MONTGOMERY COUNTY HISTORIC PRESERVATION COMMISSION
STAFF REPORT

Address:	19811 Darnestown Road, Beallsville	Meeting Date:	6/12/2024
Resource:	Darby House (Beallsville Historic District)	Report Date:	6/5/2024
Applicant:	Montgomery Parks (Scott Whipple, agent)	Public Notice:	5/29/2024
Review:	HAWP	Tax Credit:	No
Case Number:	1071643	Staff:	Chris Berger

PROPOSAL: Shed demolition, basement level alterations, grading, new door installation, other alterations.

Figure 2: The applicant provided these photos showing the condition of the rear porches.

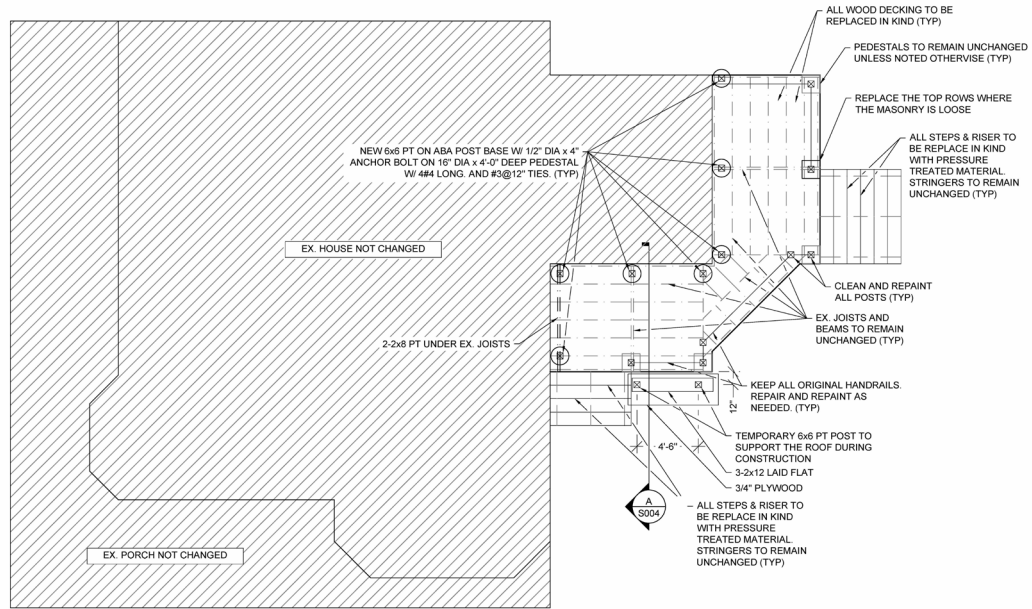
Staff supports the proposed structural improvements to the rear porches. In accordance with Chapter 24A-8(b)(1), the proposed alterations will be nearly imperceptible as the seven 6-by-6 posts with footers will be installed under the first-floor porch floor, and the 2-by-8 beams will installed be under the second-floor porch floor. Staff recommends a condition that the beams be painted to match the existing painted structural members. Further, the work is compatible with the character of the historic site, in accordance with Chapter 24A-8(b)(2). The undertaking also meets Chapter 24A-8(b)(4) because it necessary to improve the structural integrity of the porches to ensure the safety of future tenants. In compliance with applicable the *Standards*, the historic character of the property shall be retained and preserved by the work, and the alterations will not destroy materials, features, and spatial relationships that characterize the property.

The applicant also proposes to replace the rotted wood stair treads and risers and wood tongue and groove porch floors, but none of that work is subject to a HAWP because the features will be replaced in kind. The existing first floor joists and beams, stringers, and handrails will be retained.

1. The beams to be installed under the second-floor porch must be painted to match the existing structural supports.
2. The wood basement access door must be salvaged and stored on site for potential future reuse.

Areaway and basement steps

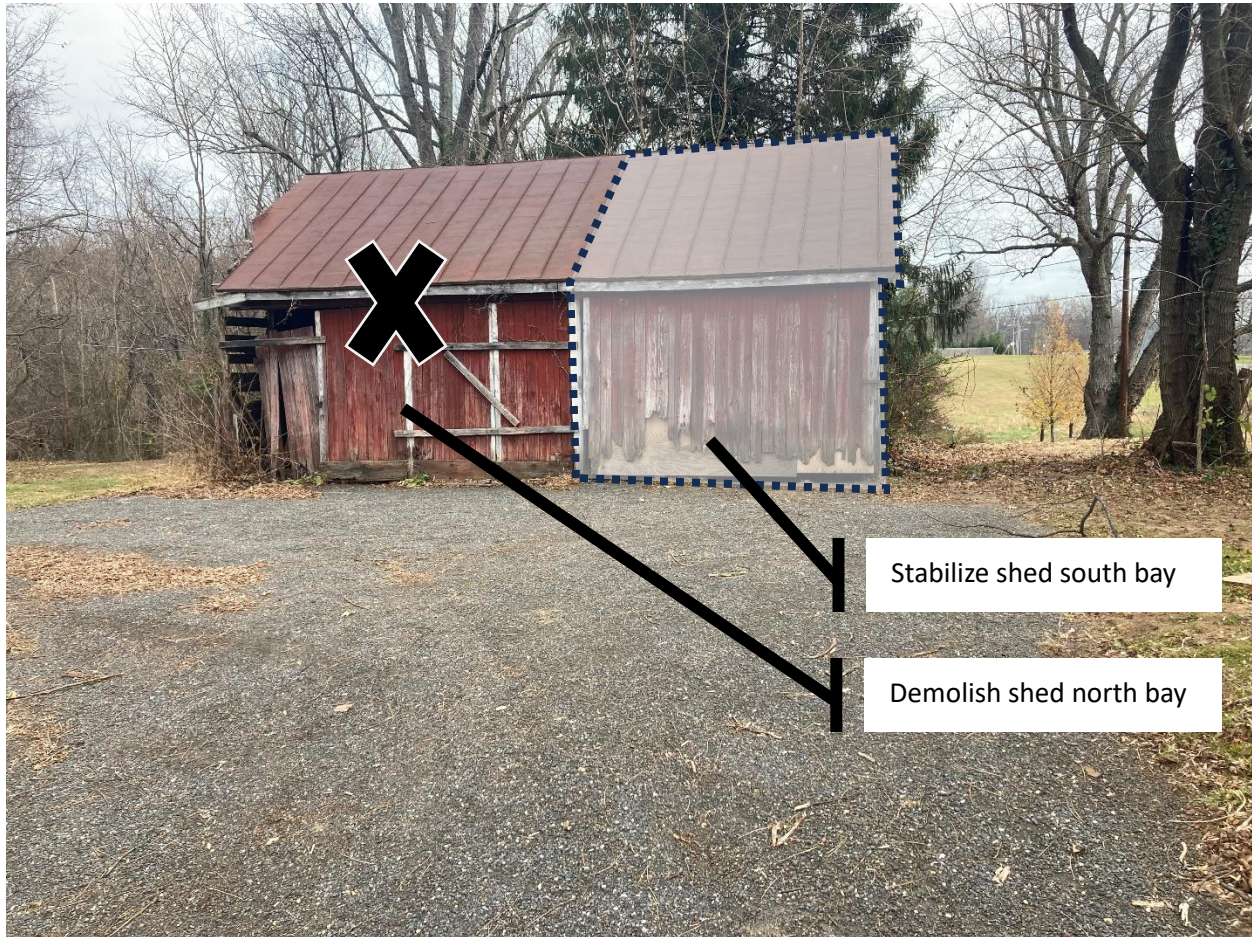
Staff supports removal of the areaway and recommends approval. The applicant will remove the stairs, wing walls, door and frame. The opening will be infilled with CMU and parged to match the existing

building. The opening will be filled with dirt and graded to divert water away from the foundation. Staff recommends a condition that the wood door be stored on-site for potential reuse on the property.

Staff finds its removal will not substantially alter the exterior features of the historic resource in compliance with Chapter 24A-8(b)(1). The low-slung areaway is toward the back of the building on the left side elevation and set back approximately 50 feet from the right of way, so it is not readily visible. In conformance with Chapter 24A-8(b)(2), the proposal is compatible with the character of the historic district. The areaway is not the only access to the basement, and, according to the applicant, the entrance is near the building's main electrical service, and water has been entering the building at that location. In compliance with applicable the *Standards*, the historic character of the property shall be retained and preserved by the work, and the alterations will not destroy materials, features, and spatial relationships that characterize the property.
